## **ADDENDUM NO. 4:**

Date: July 7, 2015  
Project: Alberta Technology Center  
Owner: The City of Tuscaloosa  
Owner's Project No: A15-0513  
Architect: Ward Scott Architecture, Inc.

This Addendum forms a part of the Contract Documents and modifies the original Bid Documents dated June 22, 2015, as noted below.

BID SET		
DATE:	06/22/15	
PROJ #:	14-028	
CITY PROJ #:	A15-0513	
REVISIONS		
#	DESC	DATE
1	ADD. #4	07/06/15
FLOOR PLAN		
A101

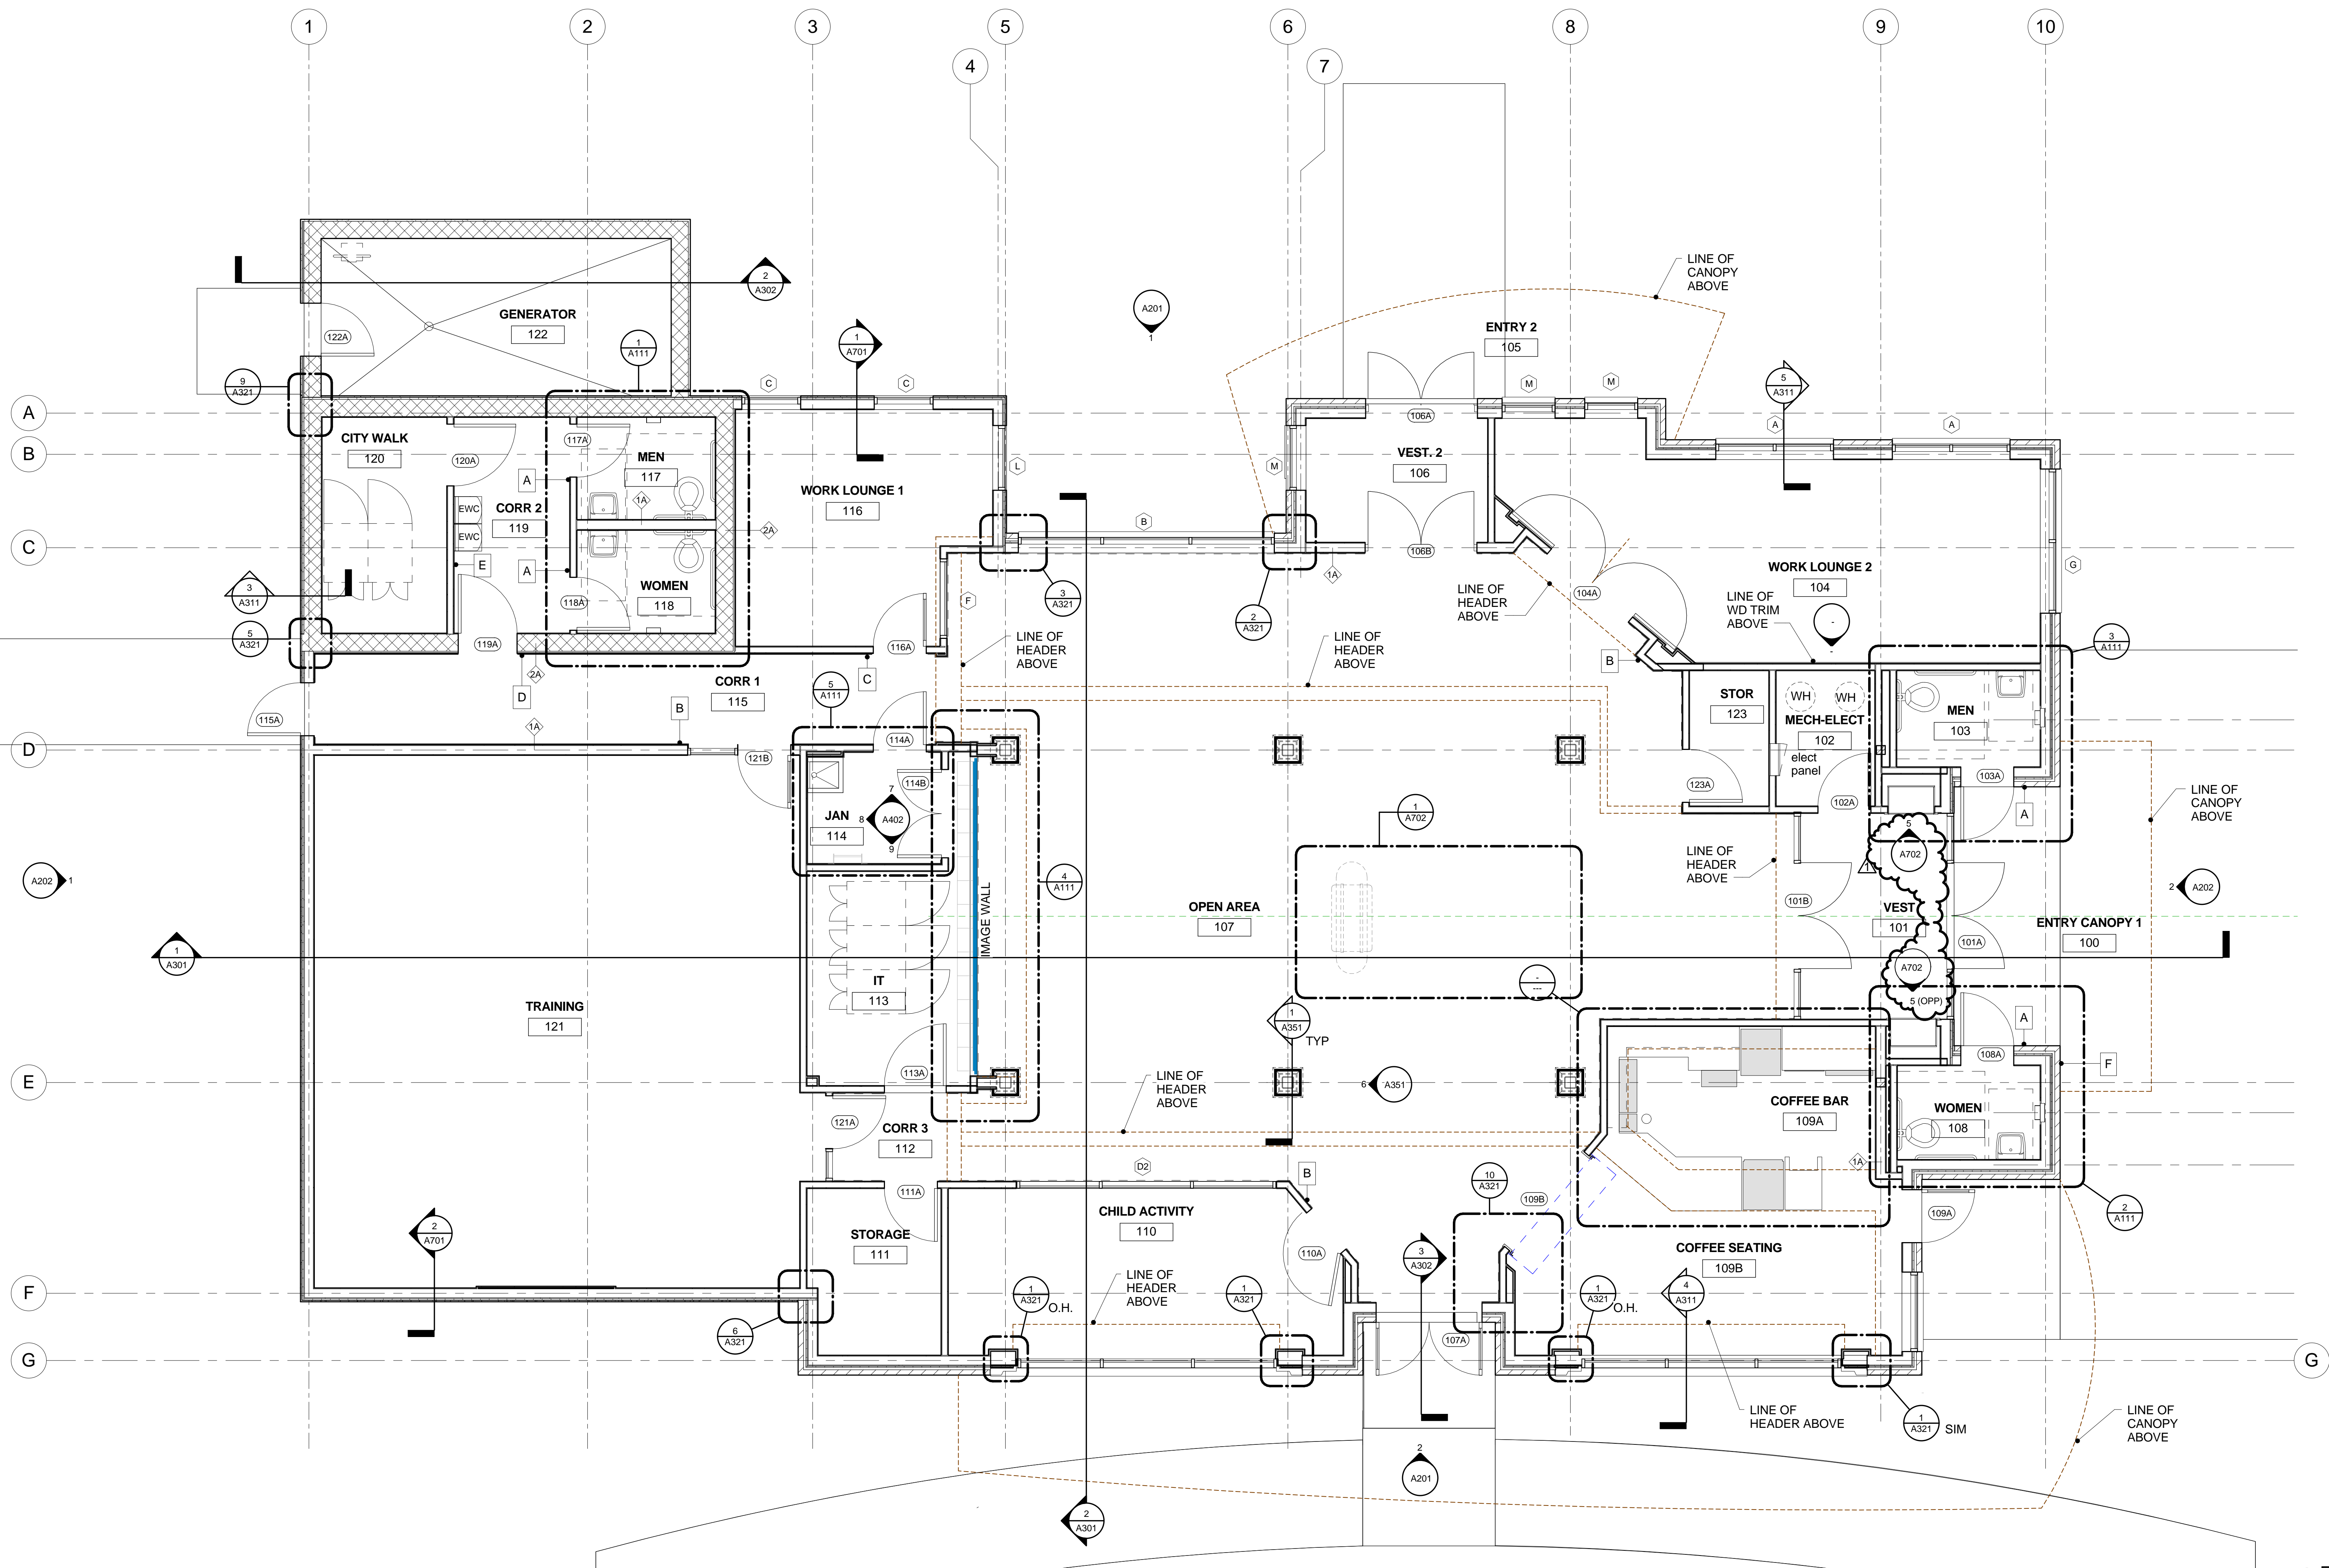
- A. The following sheets have been added:
  - 1. Sheet A502 Upper Reflected Ceiling Plan
  - 2. Sheet A702 Interior Kiosk and Details
- B. The following sheets have been modified:
  - 1. A101 Floor Plan.
    - a. Two presentation niches have been added at Vest 101 – See elevation on 3/A702. Note additional electrical puck fixtures and switches by engineer during submittals. Puck Basis of Design: Modalight, Mezo3.
    - b. Add General Note: install 10 corner guards per Architect.
  - 2. A101 Equipment Plan. Item 17 Interactive Video Wall to be purchased by (OWNER-IT), not by GC as previously indicated.
  - 3. A701 Exterior Signage. New Aluminum plate emblem added to hole in south canopy.
